In reply please quote: 13124 Revision 1

9th April 2024

MANGAWHAI HILL LIMITED PROPOSED PLAN CHANGE PPC84
GEOTECHNICAL ASSESSMENT REGULATORY REVIEW

Figure A – GIS model of the subject site with 1.0m contours and hill-shade modelling. (Source: QGIS and Northland LiDAR data). The blue line indicates the extent of the PPC84 boundary.

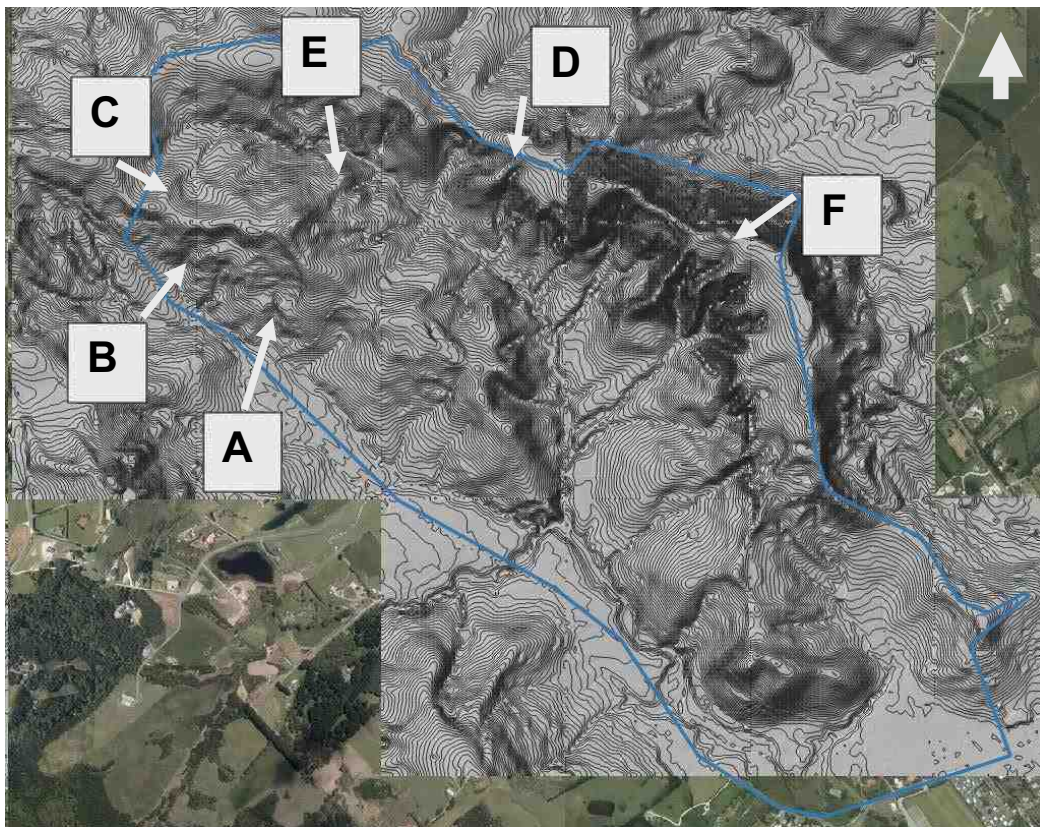
There is evidence of historic/ancient, recent, and active slope movement widespread over the property. This comprises both deep-seated and shallow slope movement, evident by visibly hummocky/undulating ground, well defined head scarps, and terracettes over the landscape. Examples of these features

are illustrated by the attached photos labelled A through F. The approximate locality of these photos and the features observed within them is indicated in Figure A above.

Figure A above presents the QGIS hill-shade model used to visually assess the subject property. Steeper slopes are observed by dark shadowing and tightly spaced contour lines. Shading in the model also aids in highlighting the property topography i.e. gives shape to historic slope movement, hummocky/undulating ground, and locates gullies. The locality of the slope instability features observed in this model and during my site walkover are highlighted in Figure B below. It is noted that slope instability features are generally concentrated to steeper slopes over the head of gullies, and towards the toe of the slopes. These feature vary from active to historic movements.

SCALE @ A3	1:8000
PROJECT No.	13124
FIGURE No.	01
REV	~

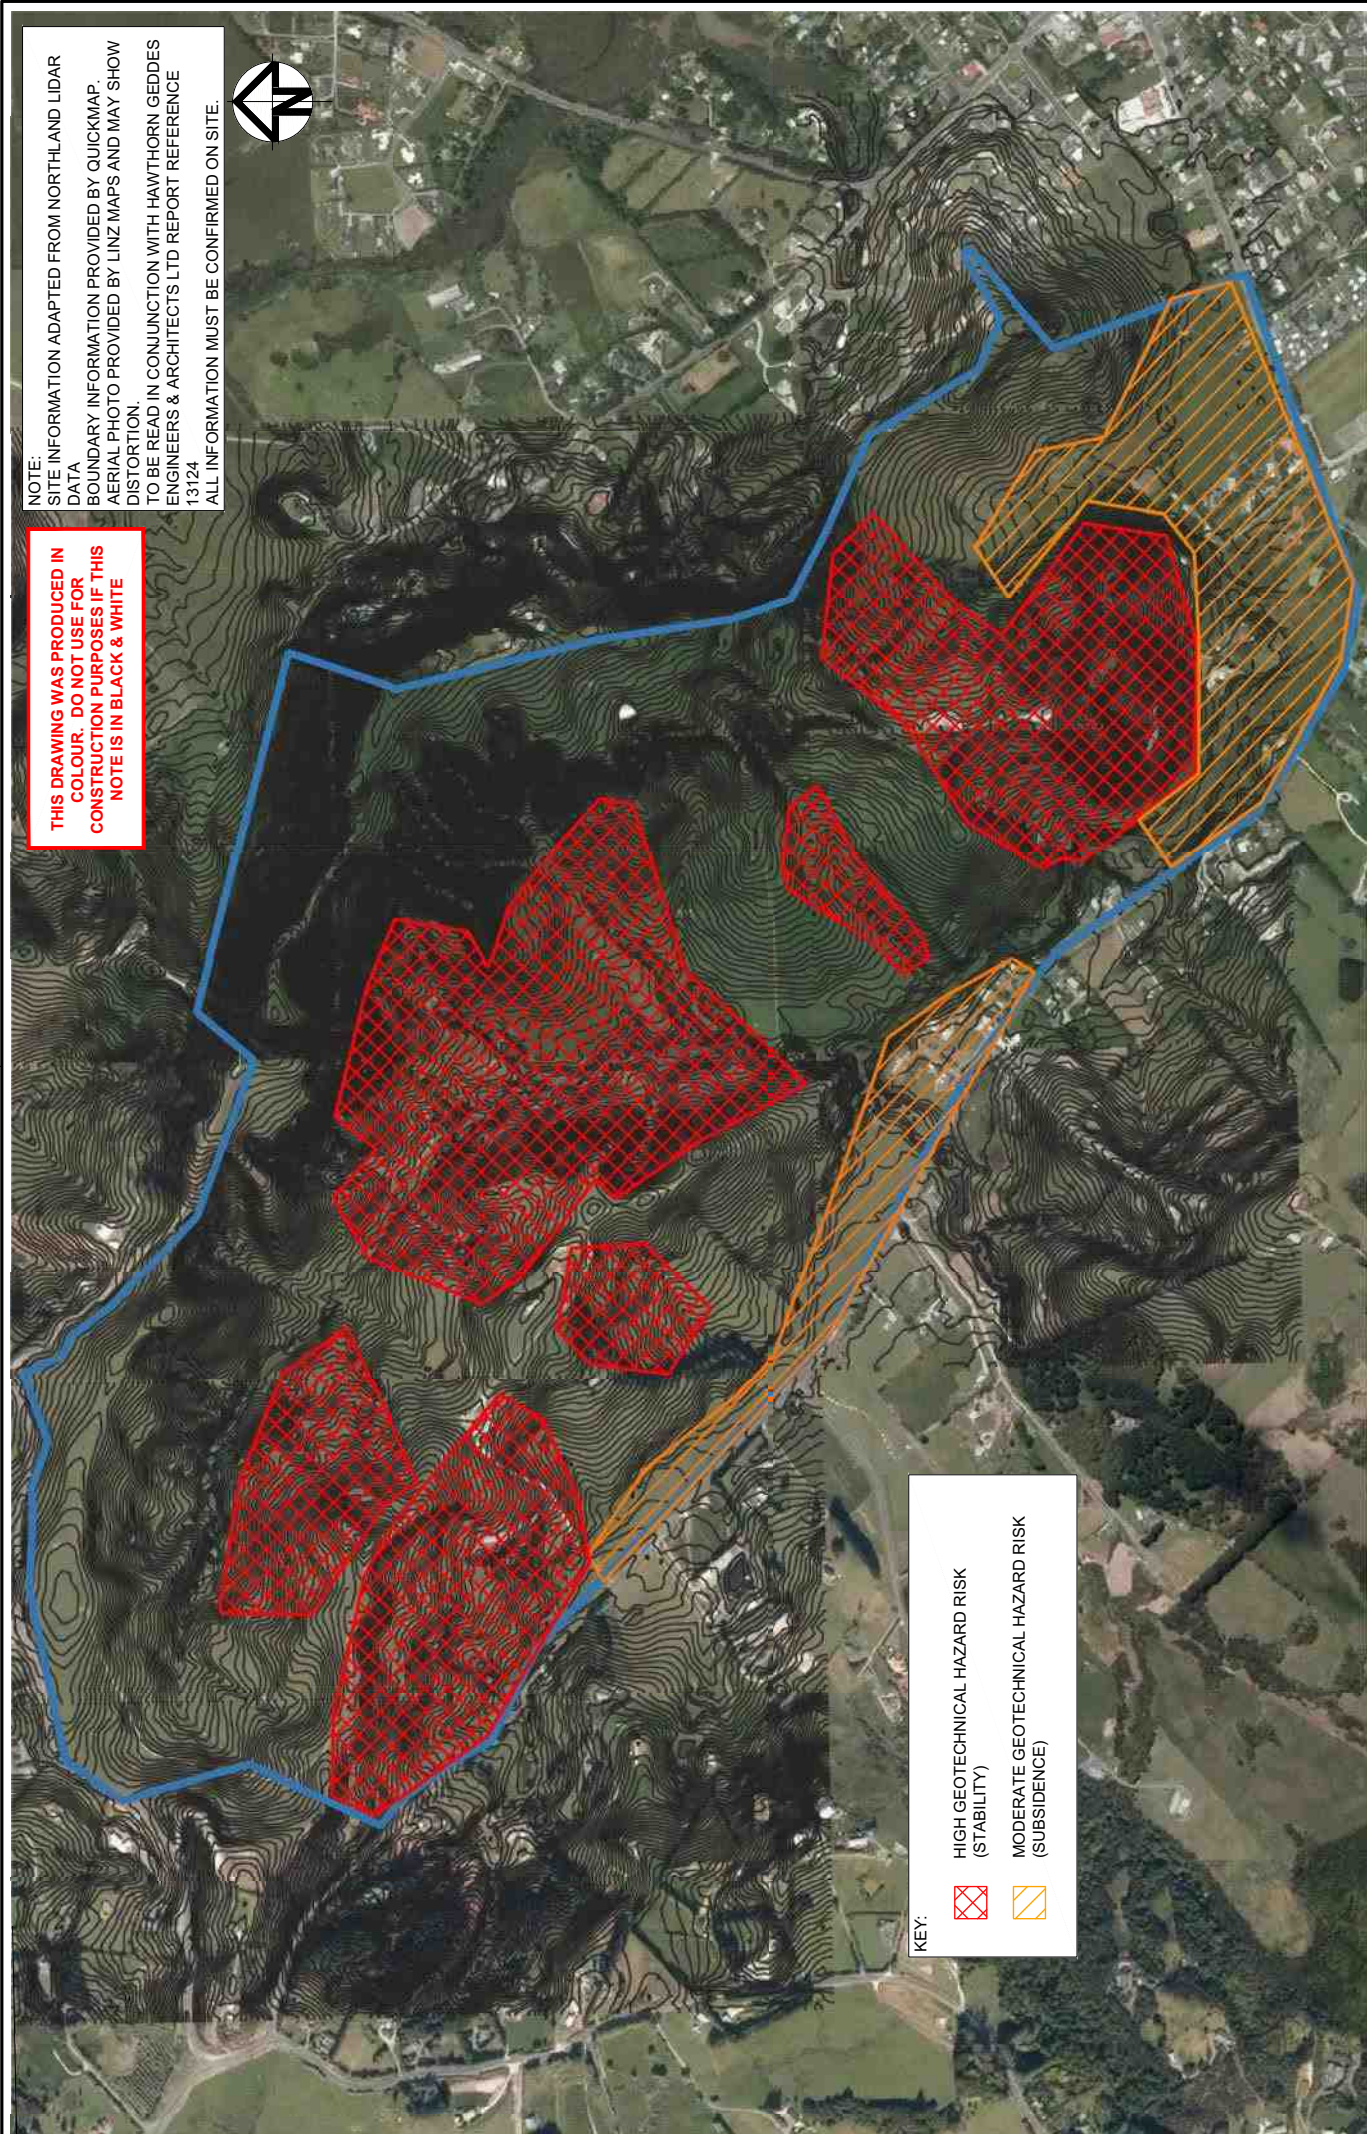
Figure C below indicates areas of the site that are within the *Proposed Residential Area* on the Mangawhai Hills Structure Plan that are considered to be prone to moderate to high slope instability and should be subject to further geotechnical assessment. Also indicated are areas of low-lying land that may be subject to settlement, and/or liquefaction. These areas are assessed based on site observations and the QGIS model.

Further investigation, associated assessment, and reporting are recommended to be undertaken in the areas denoted as *high and moderate geotechnical hazard risks*, on the attached Figure C. It is recommended that KDC request the applicant undertake further engineering assessment, to better support the PPC84 application and address the following points:

It may also be beneficial, in the areas denoted as *high geotechnical hazard risk*, on the attached Figure C, to undertake deep subsoil testing to define the nature and continuity of the strata over areas deemed prone to slope movement, with the investigation terminating at a depth below which slipping is most likely. This may be undertaken by means of test pits and/or continuous recovery core drilling to inform appropriate residential development density.
